Applicant : Rodney S. Daughtrey  
Serial No. : 10/697,823  
Filed : October 30, 2003  
Page : 6 of 16

Attorney's Docket No.: 09765-019002

Amendments to the Drawings:

FIG. 1

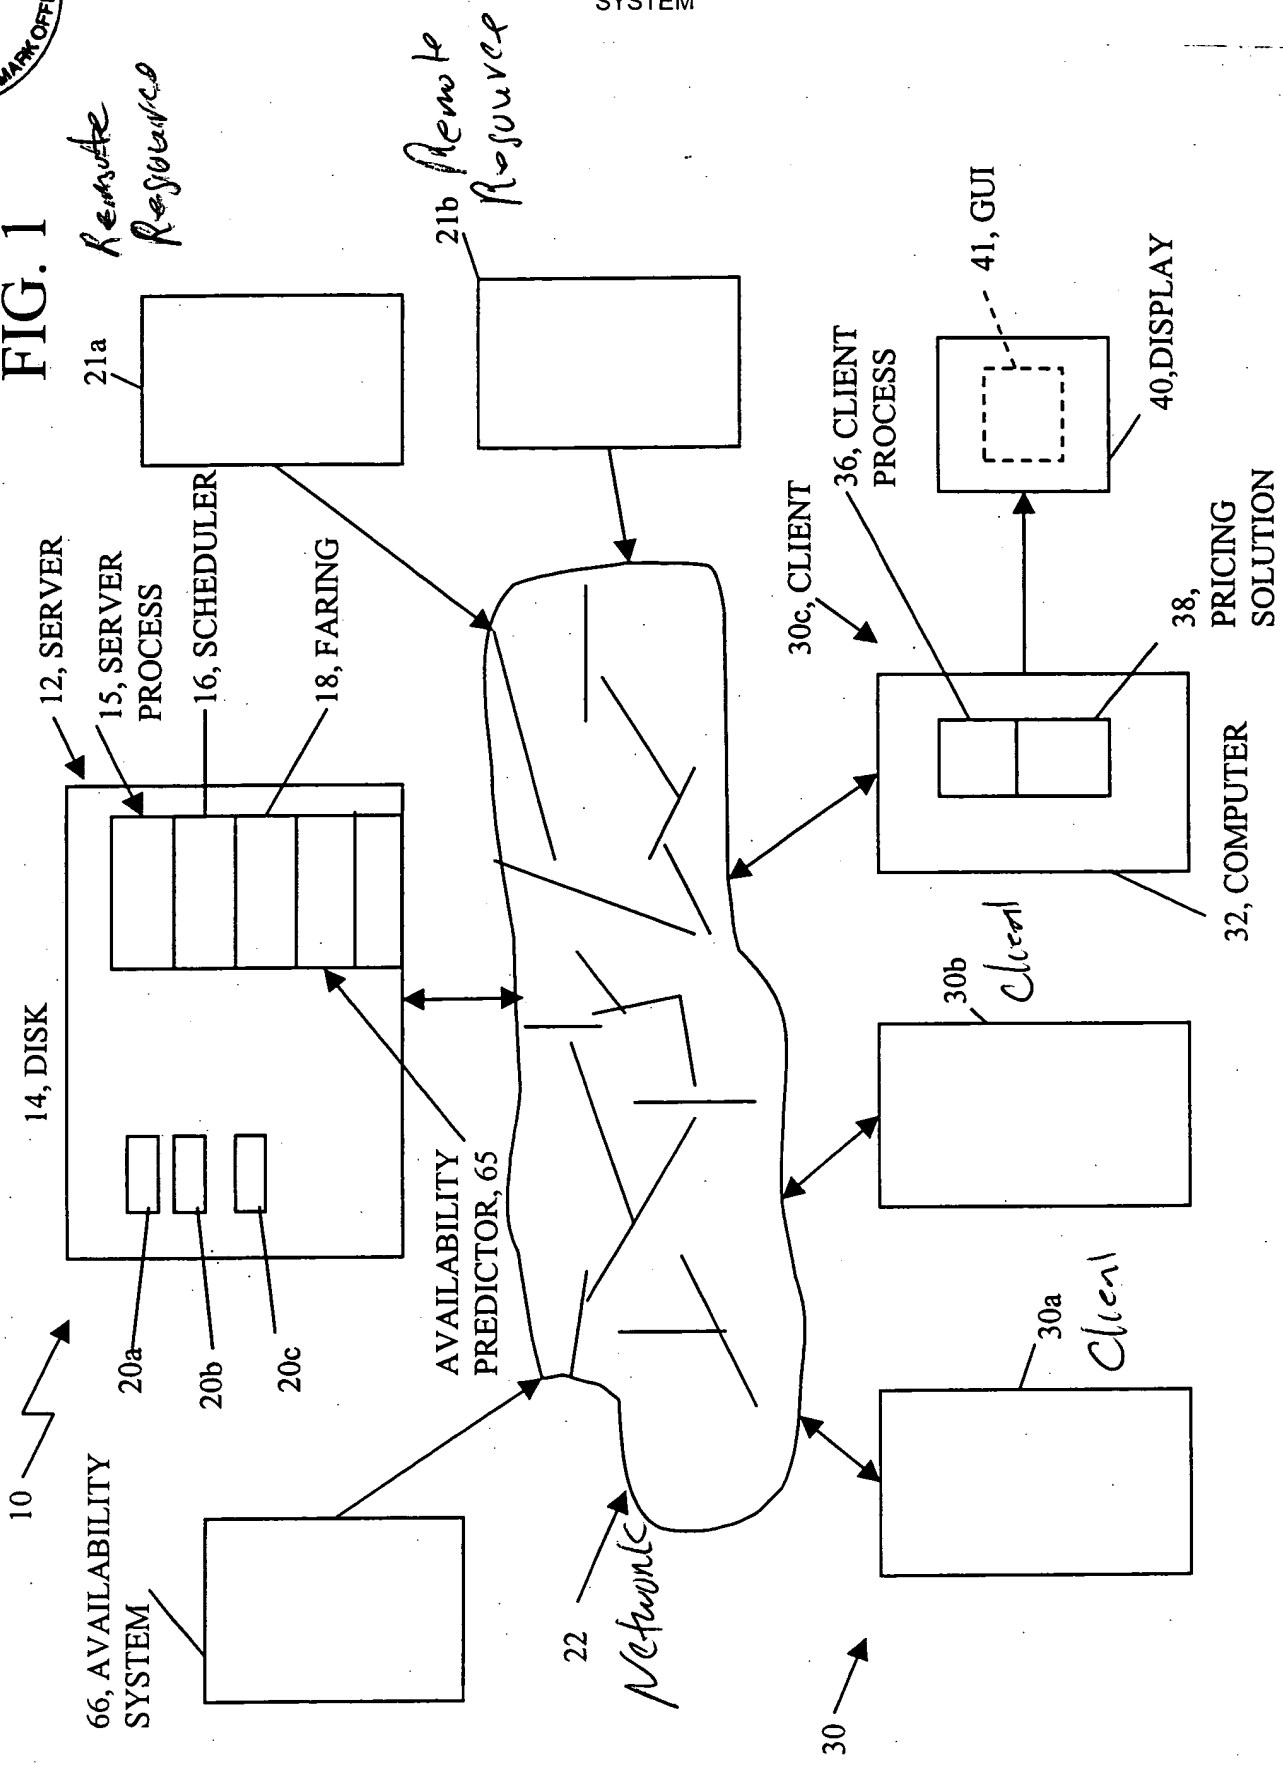
The attached replacement sheets of drawing include changes to Figs. 1 and 2 and replace the original sheets including Fig. 1 and 2.

In Figure 1, the legends "Remote Resource" "client" and "network" were added to 21a and 21b.

The examiner also indicated that boxes 21b, 22, 30a and 30b should be labeled. Applicant believes that the prior drawings submitted on July 23, 2004 included these legends. Nonetheless, Applicant has submitted new, corrected drawings and annotated sheets from the original drawings filed with the case.
